## Fwd: CH 25 comments

From: Hannes Stueckler <hannes.stueckler@wyo.gov>  
Date: Mon, Feb 4, 2013 at 5:07 PM  
Subject: CH 25 comments  
To: William Tillman <william.tillman@wyo.gov>

To: Bill Tillman  
 From: Ronald Ewald, Assistant Southeast District Engineer  
 Water Quality Division, Wyoming DEQ  
 Date: February 27, 2013  
 Subject: **DRAFT2 Chapter 25 – Comments, Questions, and Concerns**

FIGURE 1

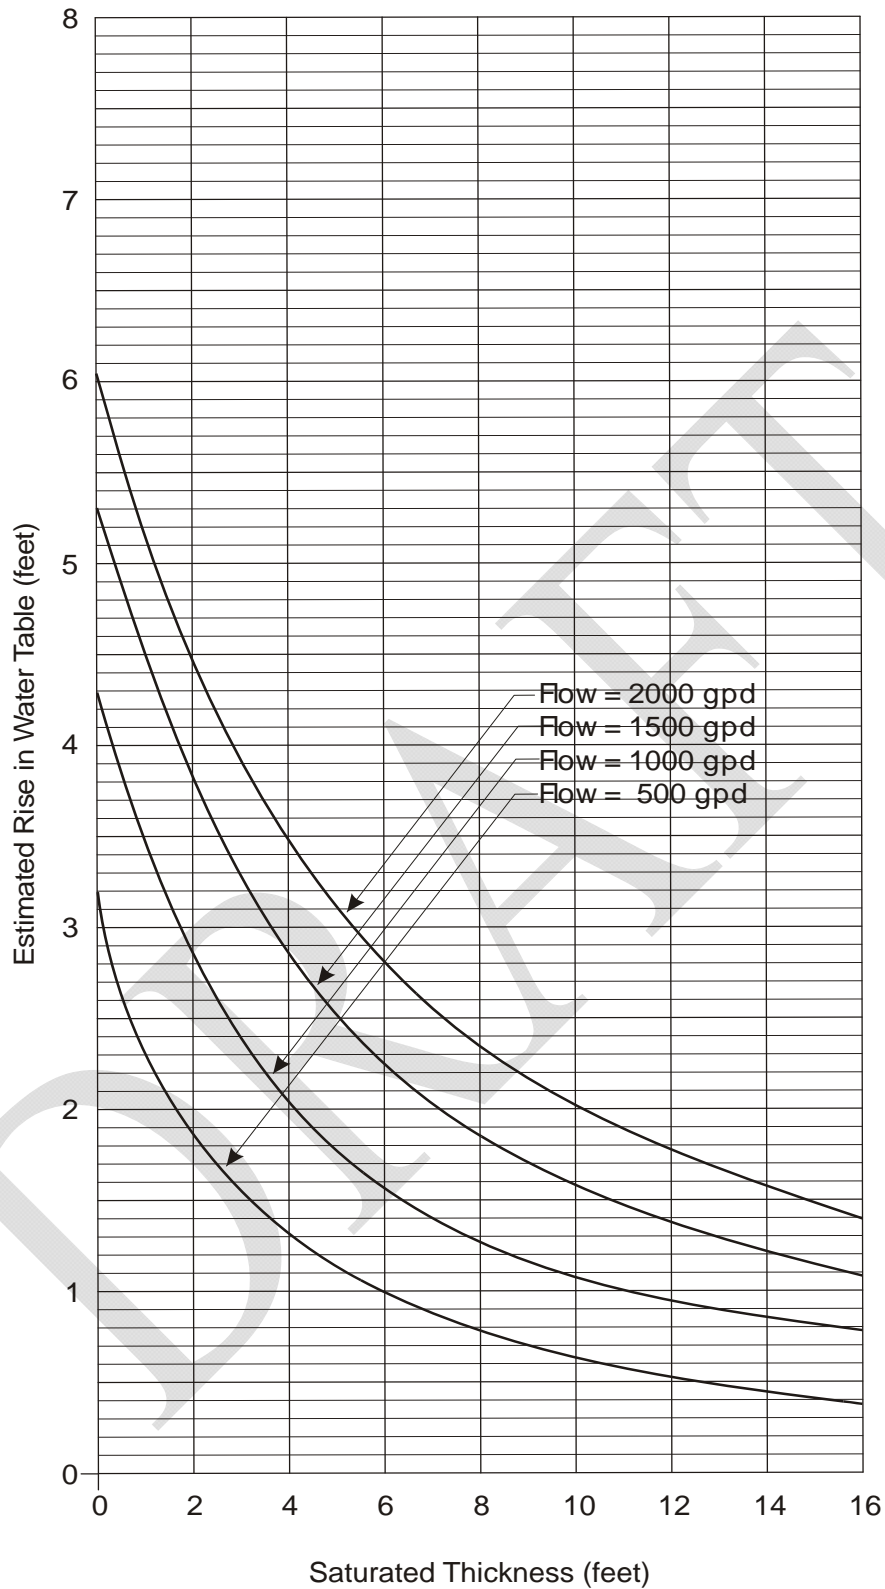
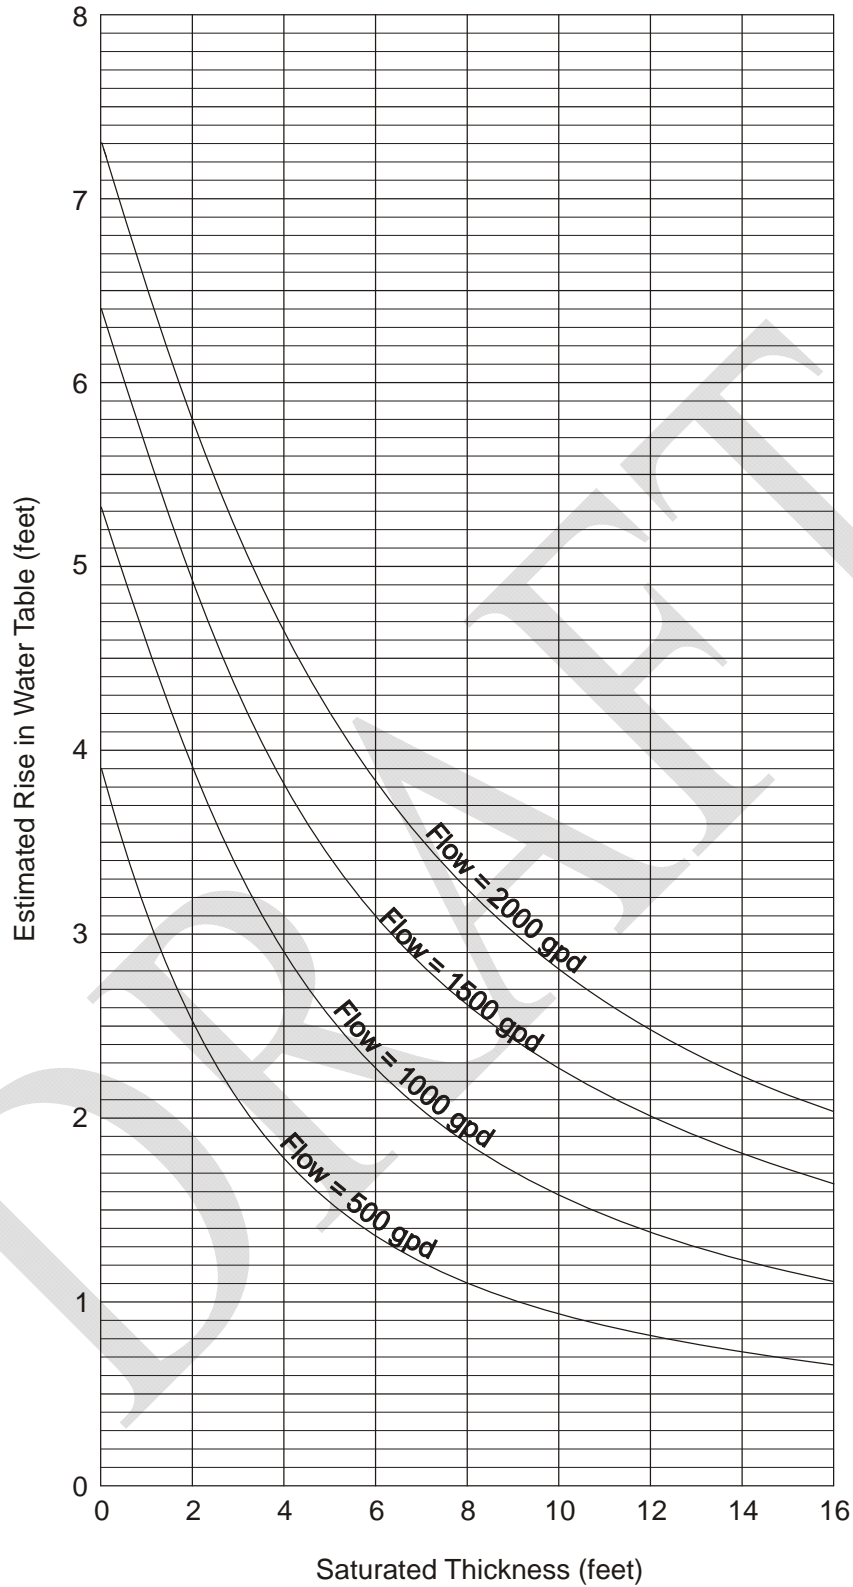
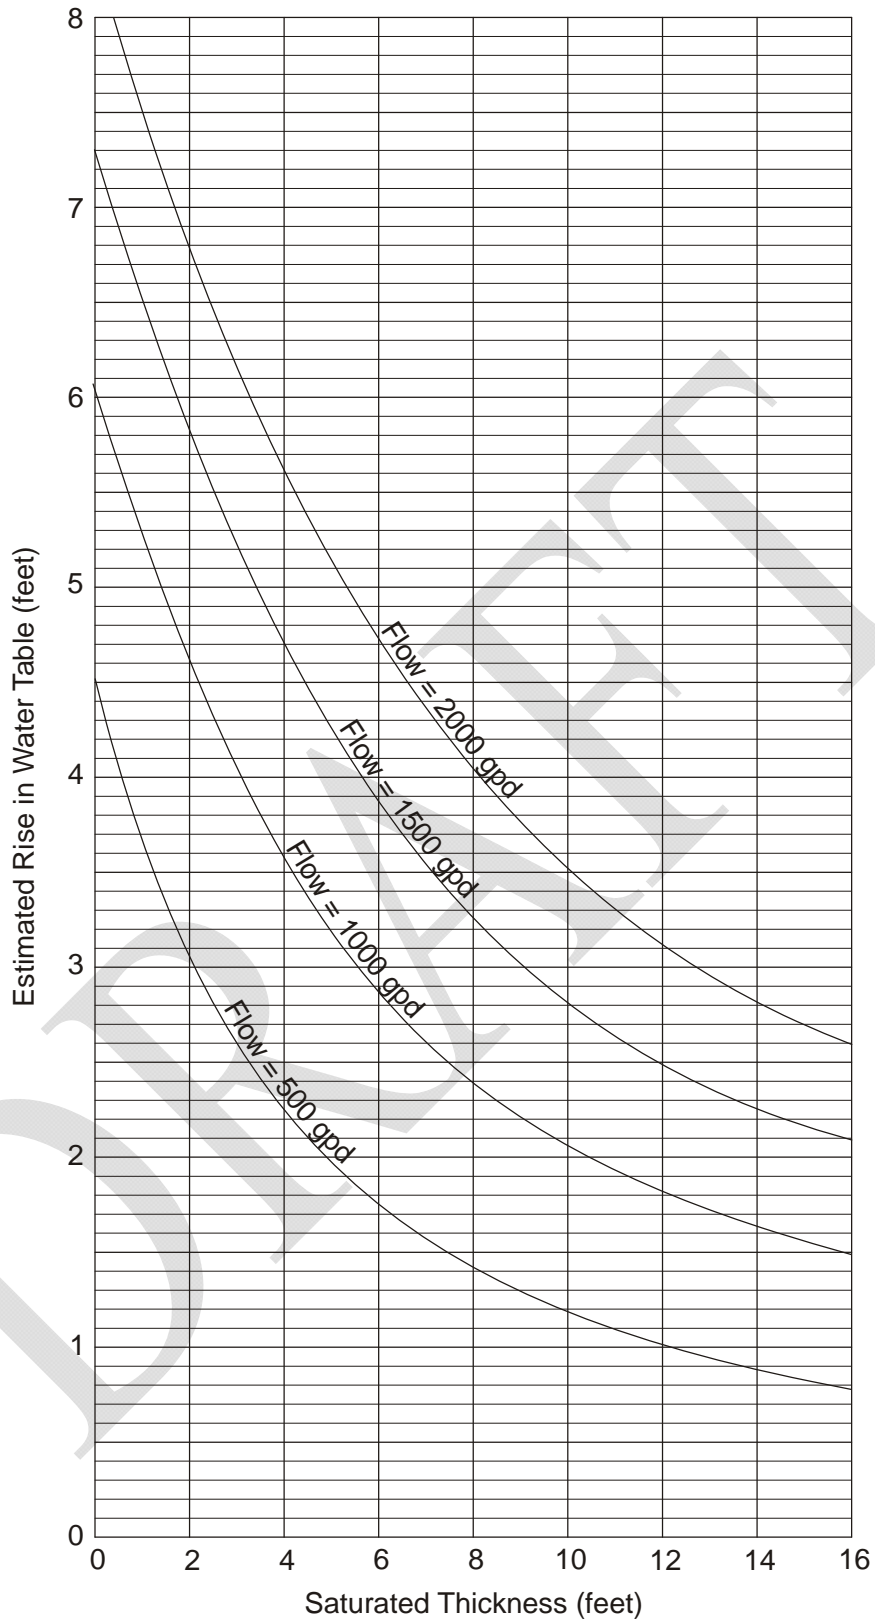
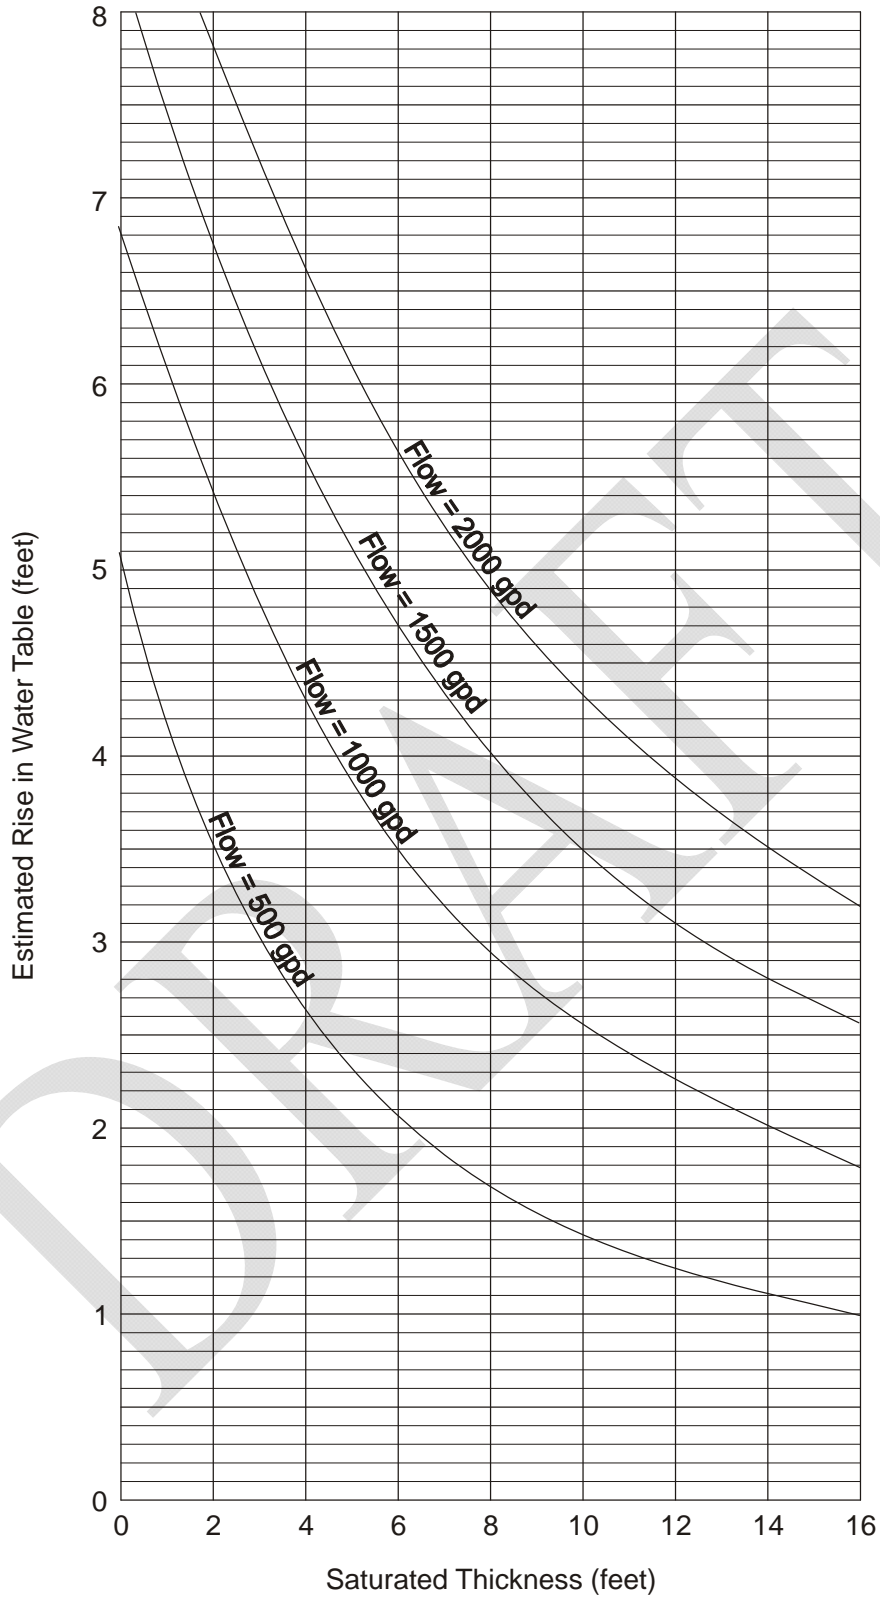
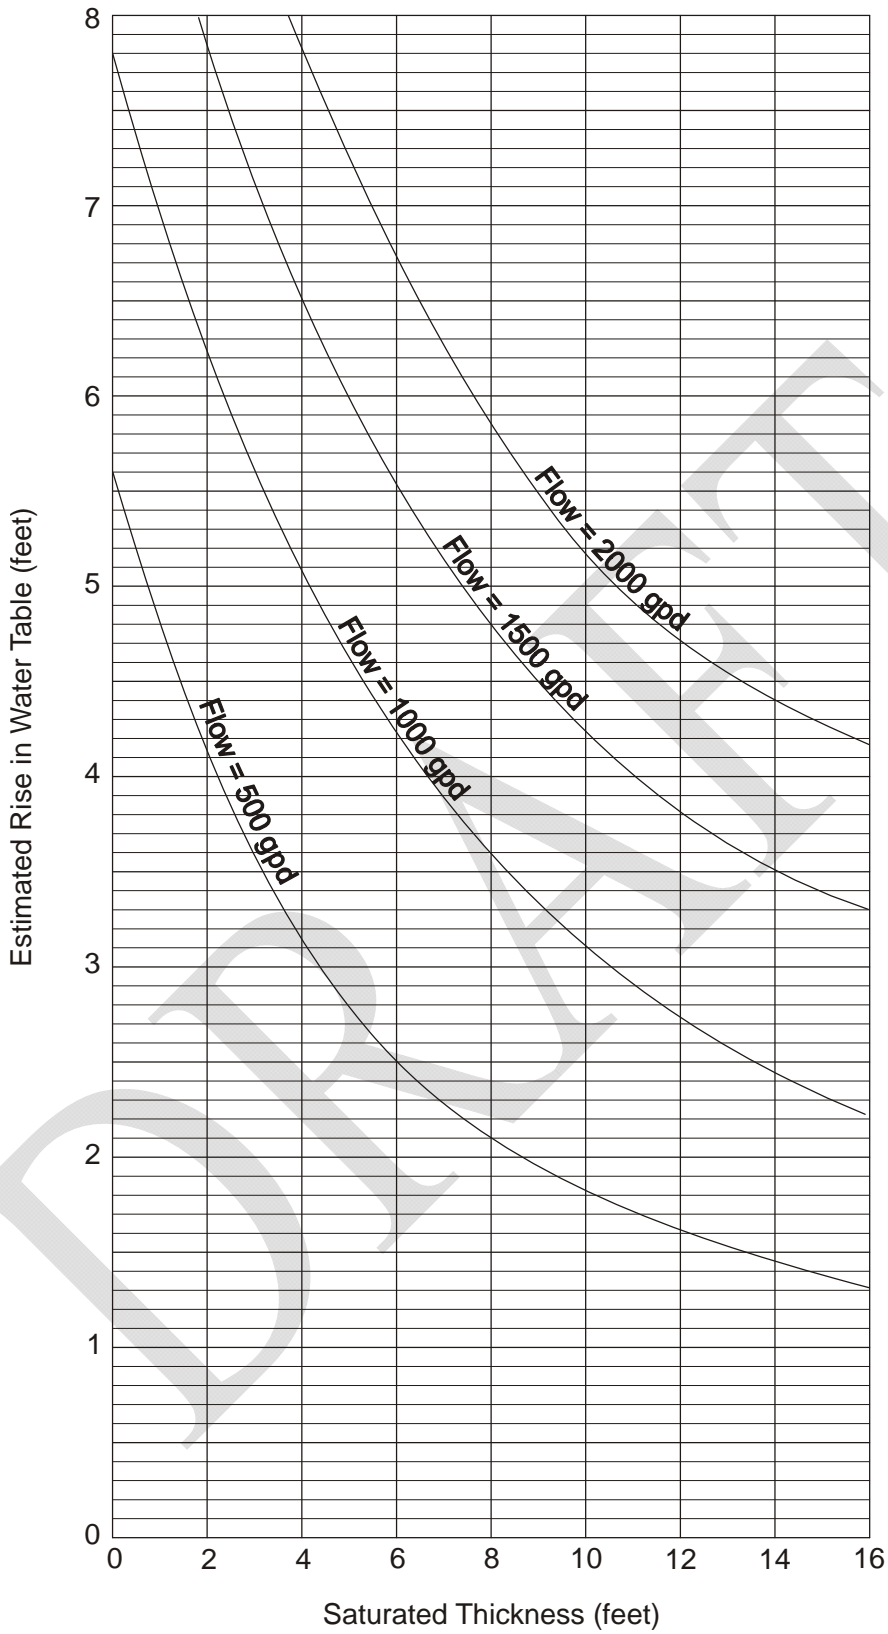
(d) Question: Is the mounding from figures 1 - 6 to be added to the 4 foot separation requirement under all circumstances? This would mean that our ground water separation distance requirement for a typical residential application would have increased from 4 feet to between 4.2 and 9.5 feet. This is contrary to practices found elsewhere and to evidence indicating that four feet may be too conservative.
